ADDENDUM NO. 2
to
CONTRACT DOCUMENTS

for
ADDITIONS AND RENOVATIONS TO LITTLEBROOK ELEMENTARY SCHOOL
located at 39 Magnolia Lane, Princeton, NJ 08540

FVHD PROJECT NO. 5516D

Issued: March 24, 2026

6

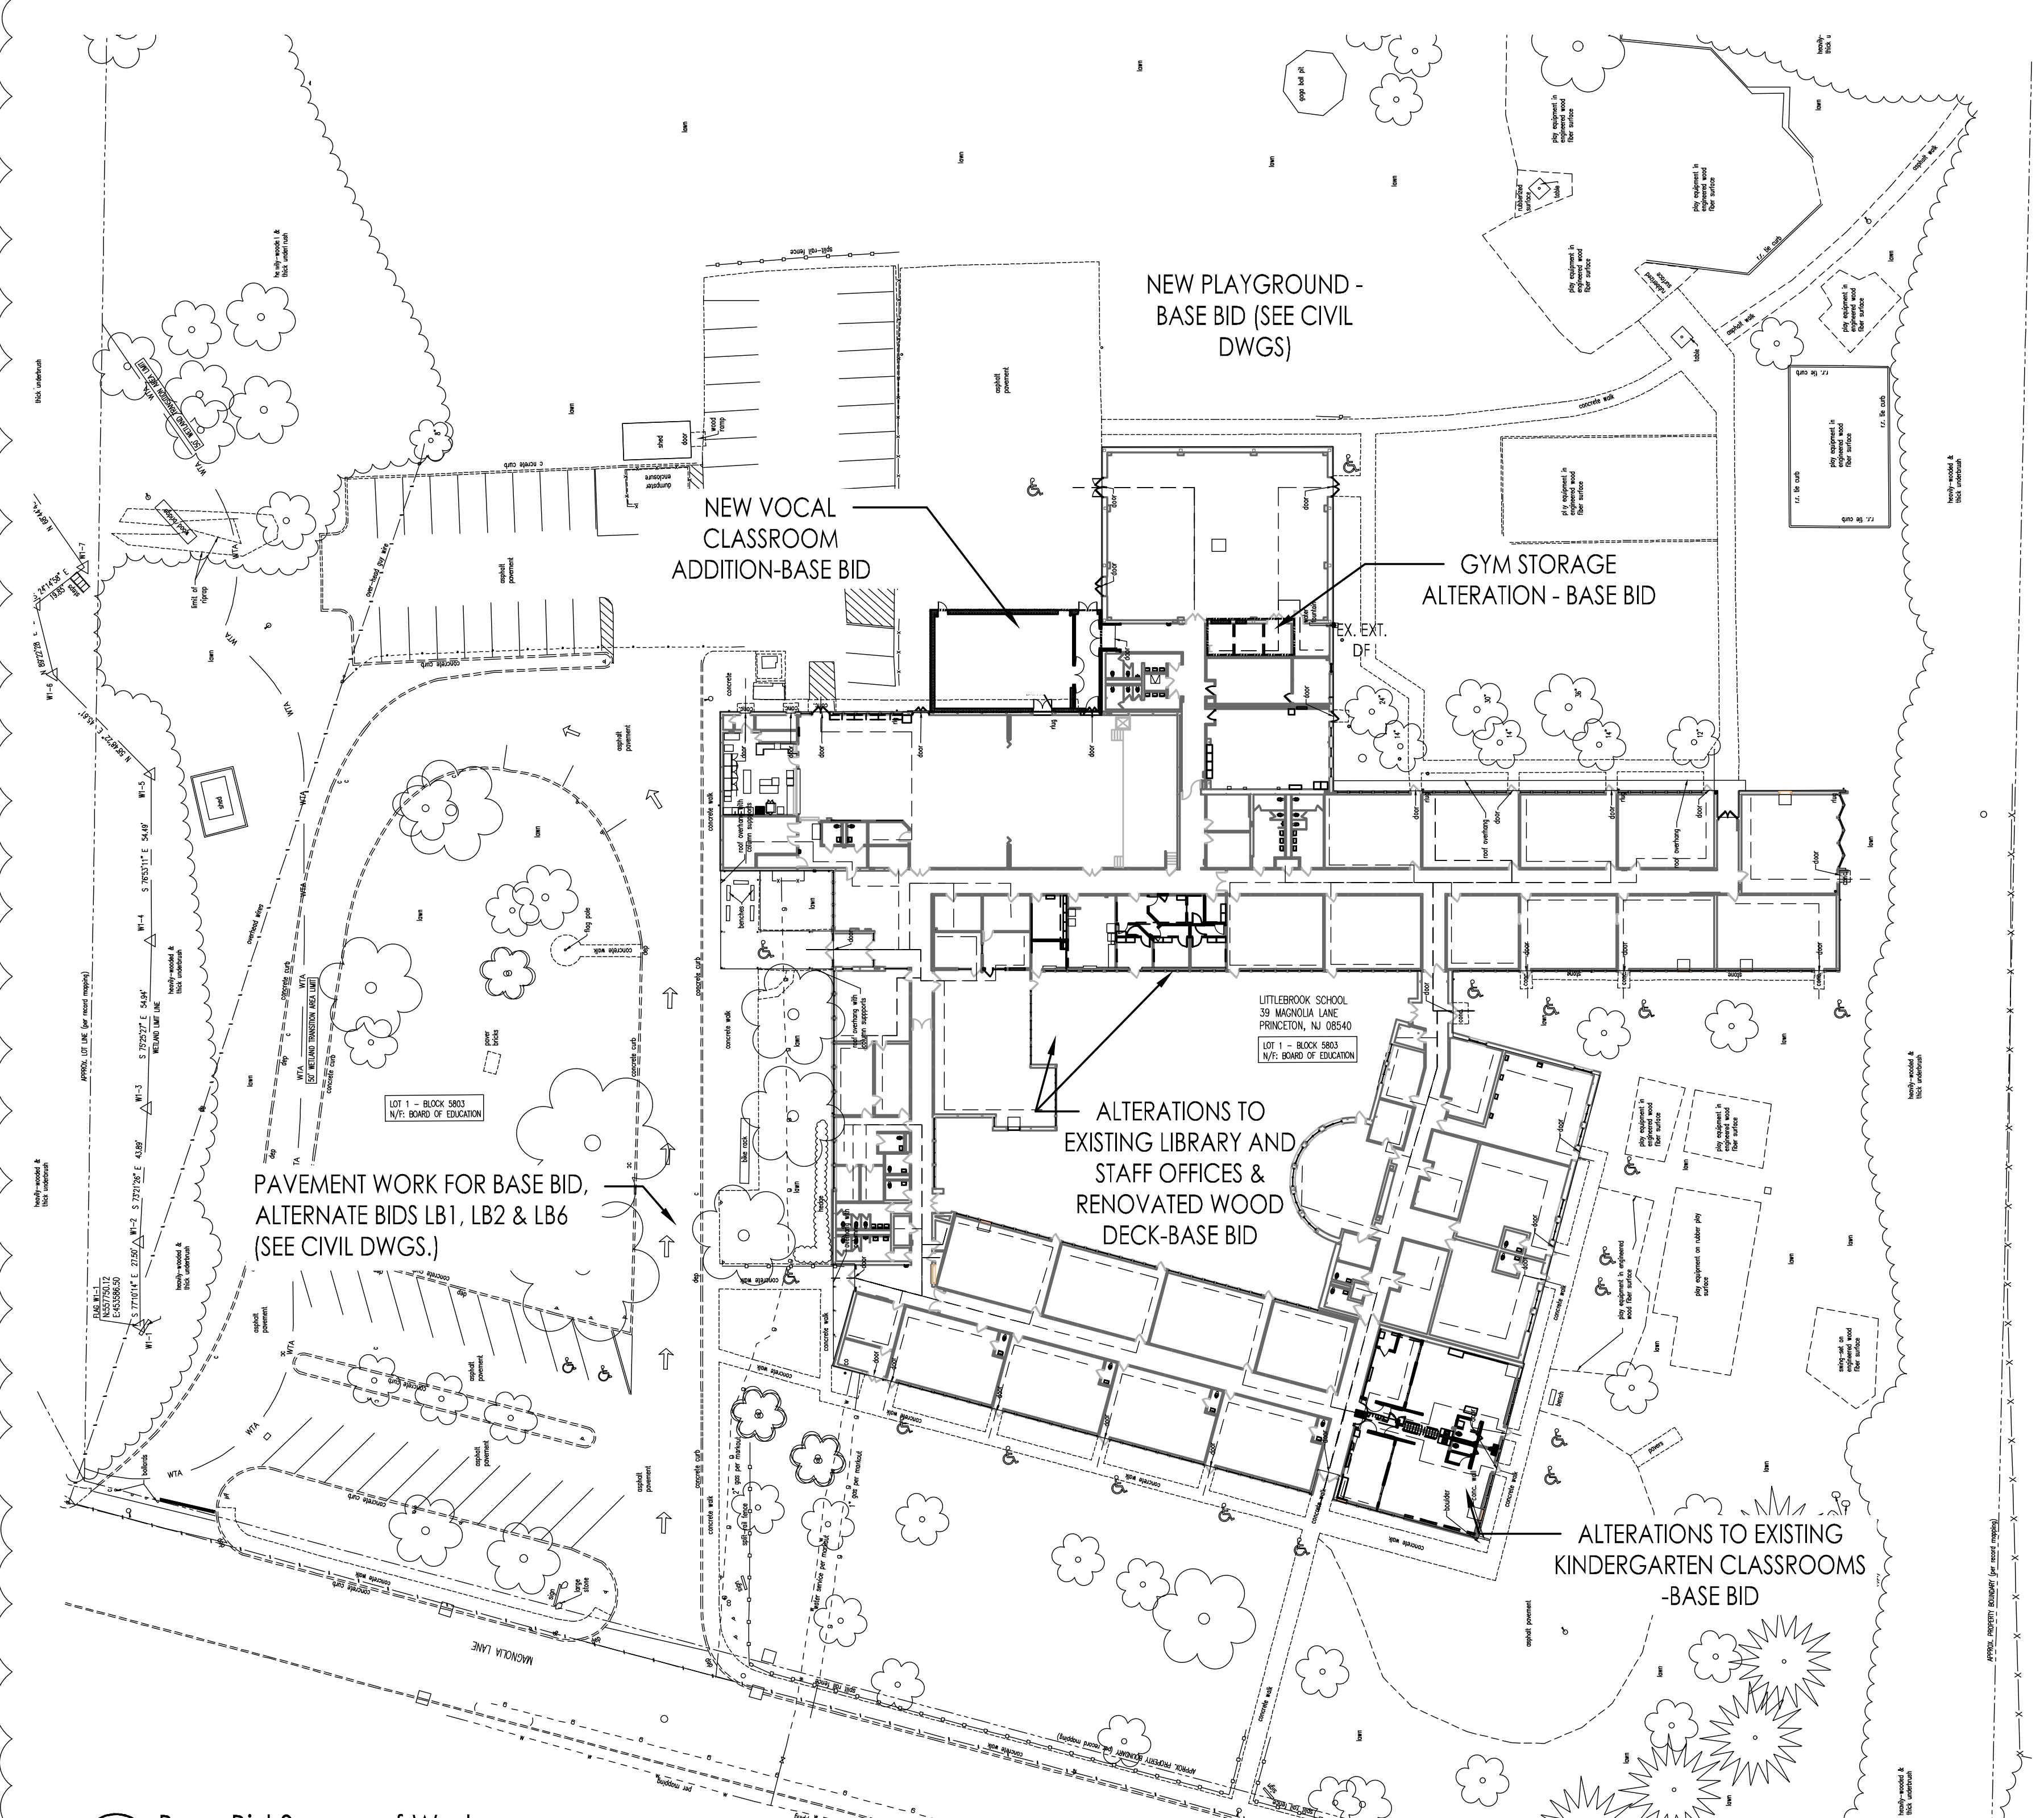
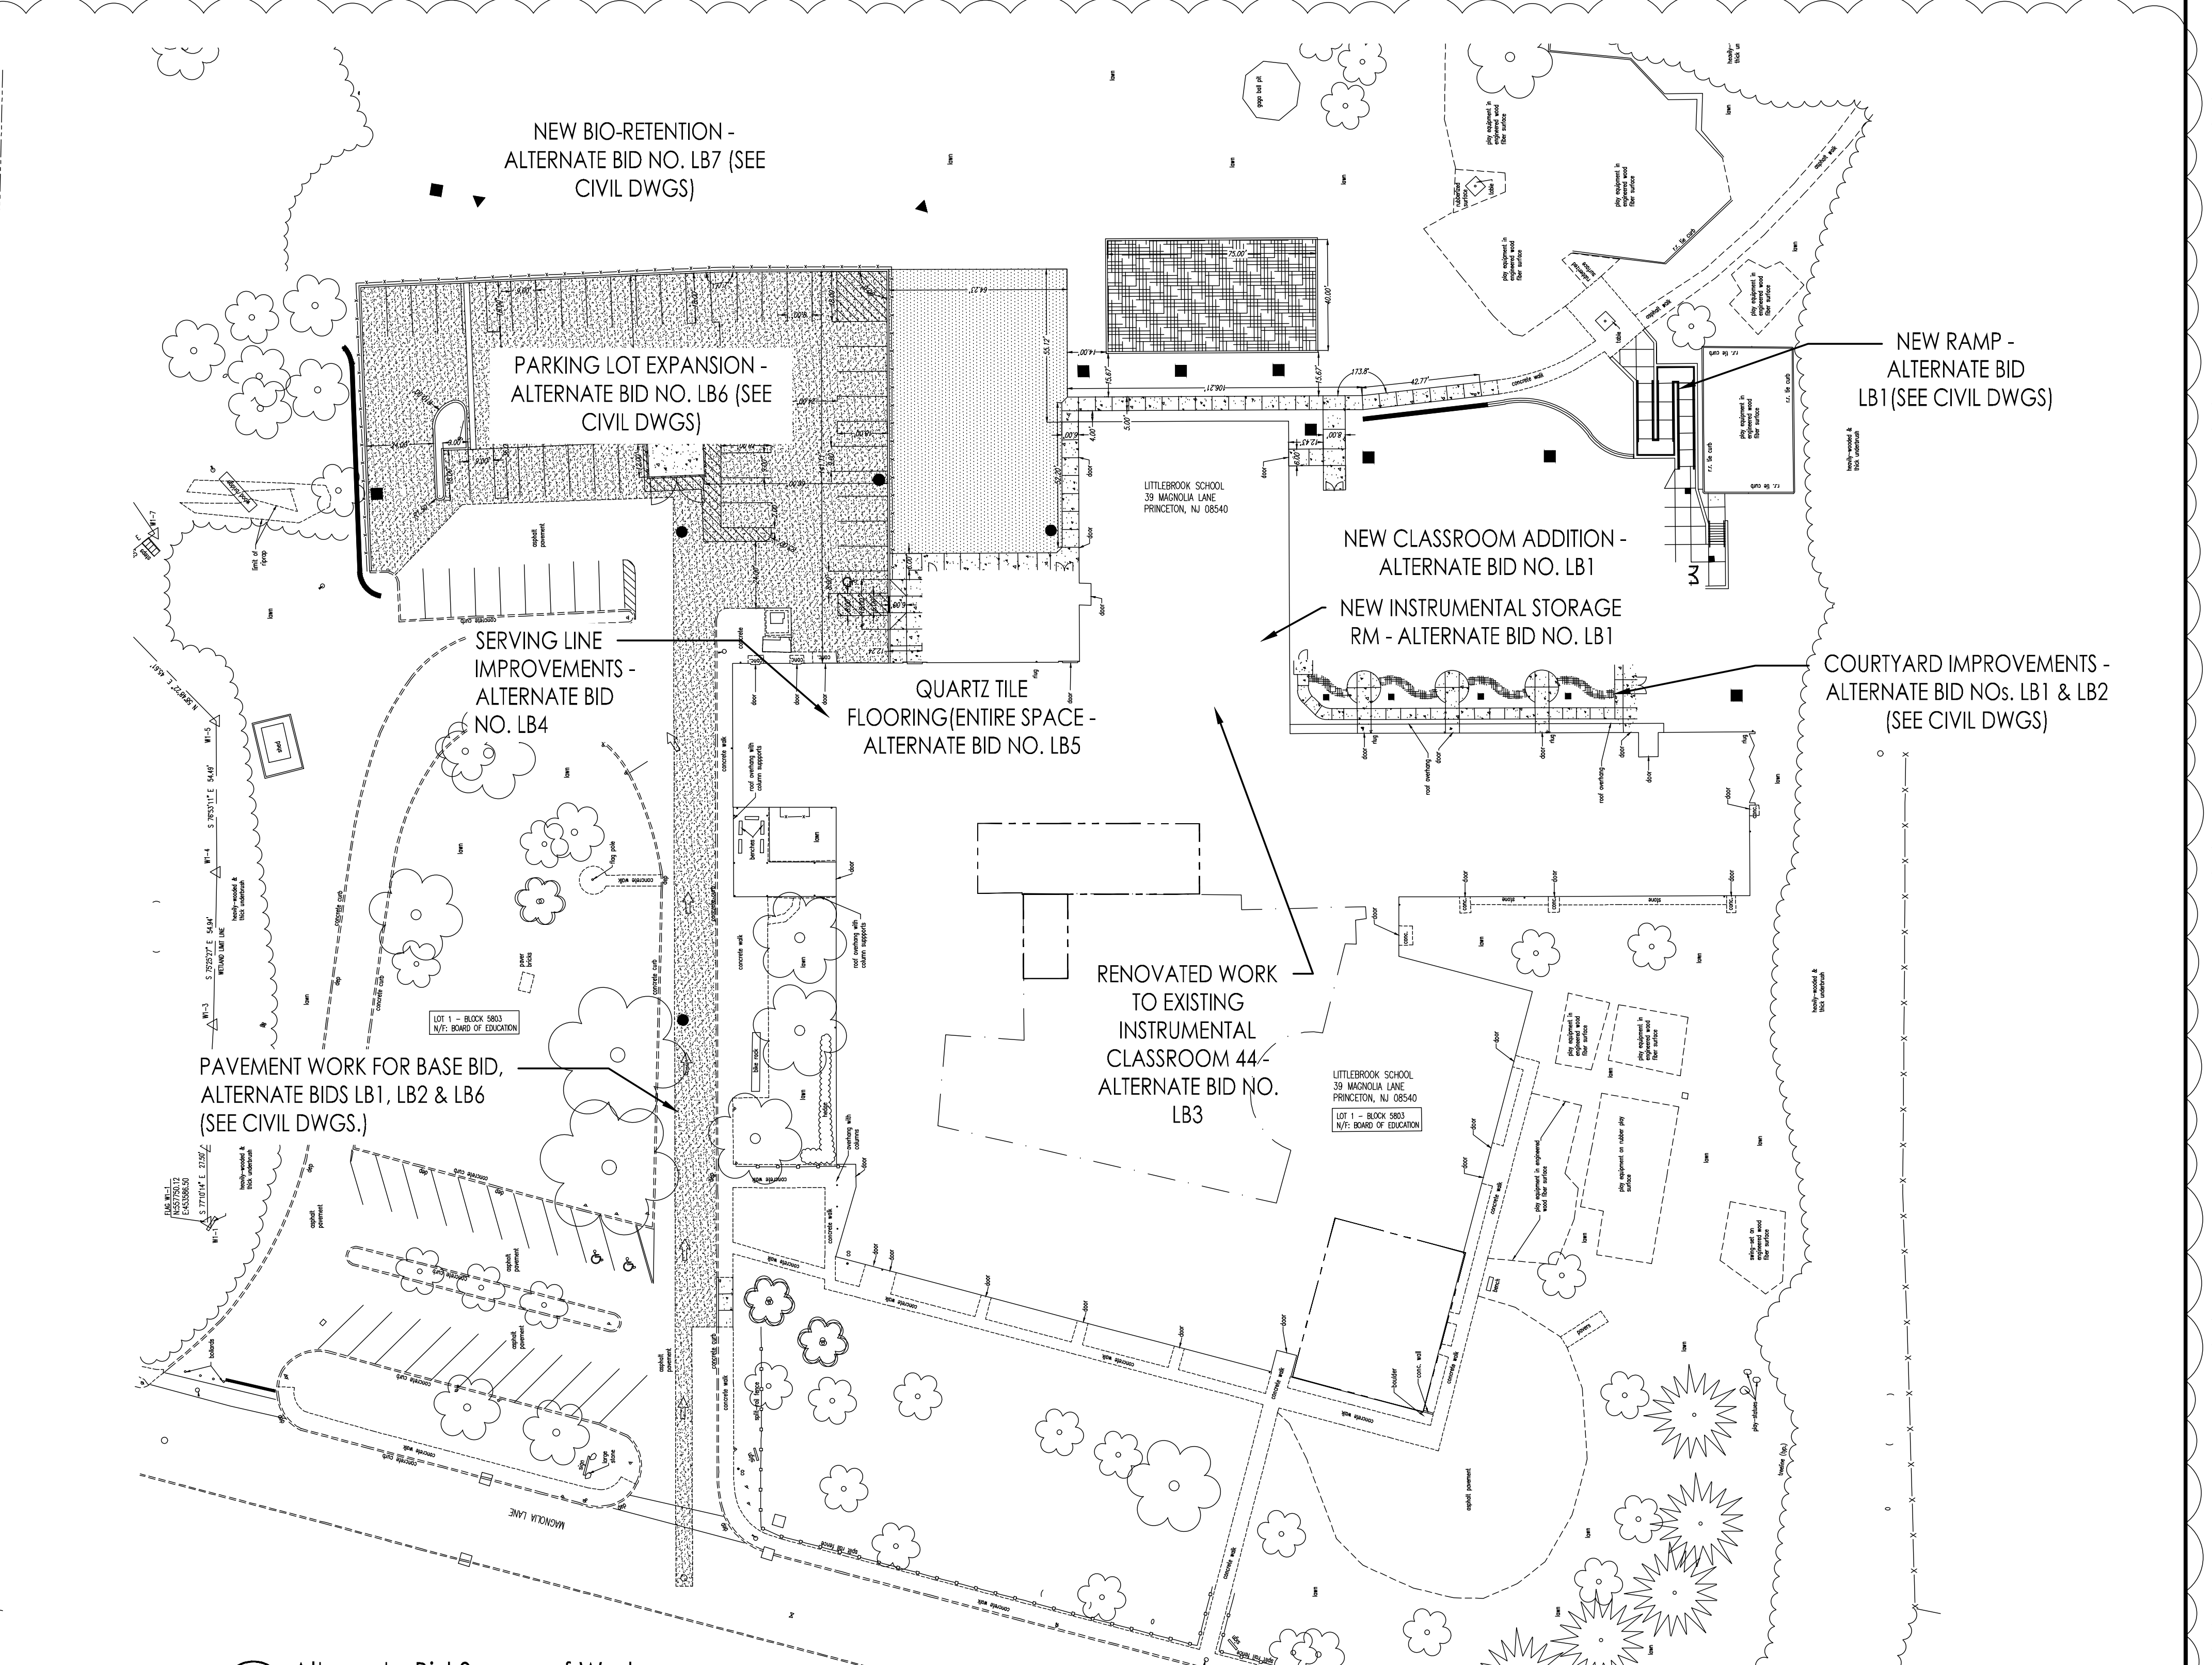
21. Question: Please provide layout and locations for temporary Partition if any requirement.

Response: Refer to Specification Section 01505, para 1.1, C.16. Refer to locations on revised drawing A001.
